MANDATORY SERVICE BULLETIN Z 142C/11a - Rev. 1

Z 242L/18a - Rev. 1

Z 143L/4a - Rev. 1

3. SUBJECT: During the operation some cases of loosening

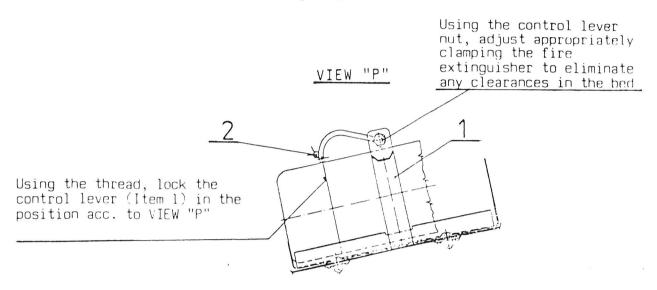
4. CORRECTION: Replacement of the fire extinguisher original

holder Drwg. No. Z 143.8263-01.00 by the modified type Drwg. No. Z 143.8264-01.00.

- Install the modified type of the fire extinguisher holder Drwg. No. Z 143.8264-01.00 (Item 1) onto the original location on the floor, insert the fire extinguisher and secure it using the thread and the seal (Item 2) as shown on the following Figure:

- The fire extinguisher holder Drwg.
  - No. Z 143-8264-01.00
- The seal PE 6 x 7
- The raw-flax threads 105 x 4 ON 80 2154 L = 300 mm.
